ADDRESSEES	: Owners and operators of vehicles mentioned under “Application” ABC Customer Care and Parts Source
VEHICLE TYPE	: CX45 with electric cooling fan drive
CONFIGURATION GROUP	: 2.46 Traction engine – Accessory drive
BULLETIN TYPE	: Field change program
DATE	: April 29th, 2025
SUBJECT	: To install a refrigerant compressor bracket reinforced anchoring point
CONDITIONS	: Refer to chapter "Warranty" further on in this bulletin.

VDL Van Hool has determined an issue regarding the refrigerant compressor bracket anchoring point at the engine side on the above mentioned vehicles.

Figure 1: Refrigerant compressor bracket anchoring point

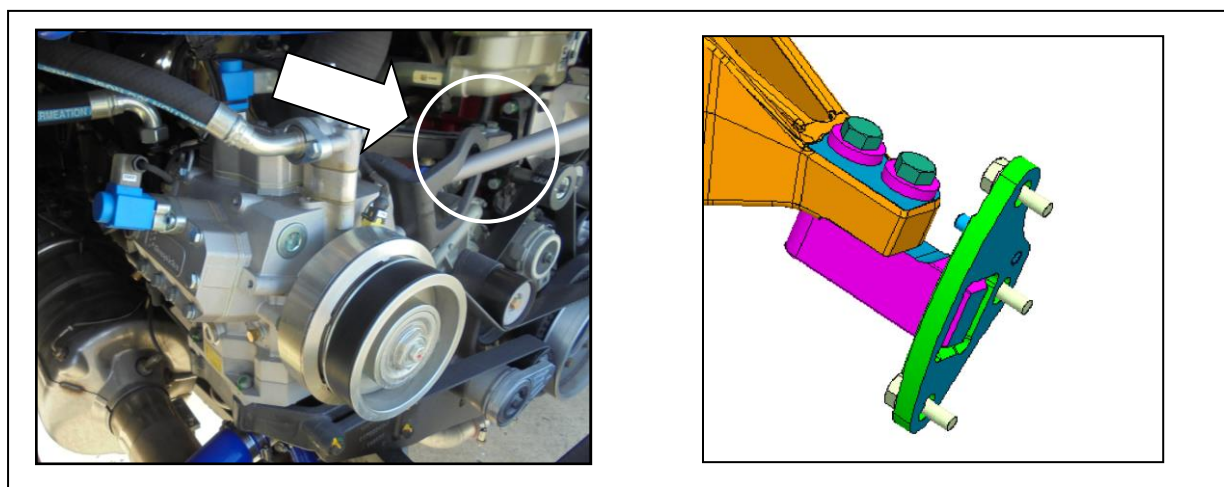
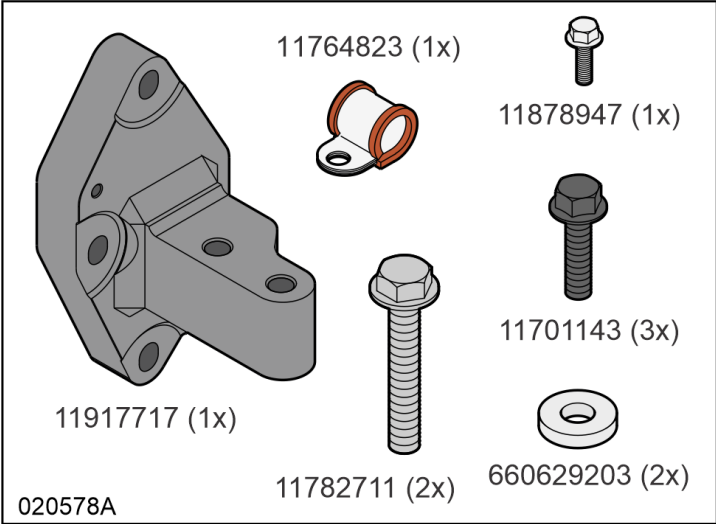
To address this issue, VDL Van Hool is conducting a field change program whereby the anchoring point must be replaced by a reinforced type. What to do exactly is explained in this service bulletin.

Step	Action
1	Open the engine compartment rear access door.
2	Remove the original anchoring point.
3	Install the reinforced anchoring point from the kit as follows. - Secure the reinforced anchoring point to the engine block by using the three M10 flanged screws (VH11701143) from the kit. To become a tension-free installation at the end, only hand-tighten the three screws at this stage! - Place the spacers (VH660629203) from the kit onto the two M12 flanged screws (VH11782711) from the kit. Do not reinstall the old spacers! - Apply Loctite 243 on the thread of the two M12 flanged screws. - Install the two M12 flanged screws (provided with new spacers) to secure the refrigerant compressor bracket to the anchoring point. To become a tension-free installation at the end, only hand-tighten the two screws at this stage! - Finally tighten the three M10 flanged screws to 60 ± 9 Nm (44 ± 7 ft.lbf). - Finally tighten the two M12 flanged screws to 100 ± 15 Nm (75 ± 10 ft.lbf). - Secure the nearby electrical cable with the cable clamp (VH11764823) from the kit to the reinforced anchoring point. Tightening torque of M6 flanged screw (VH11878947): $8,6 \pm 1$ Nm (6 ± 0.7 ft.lbf) Figure 3
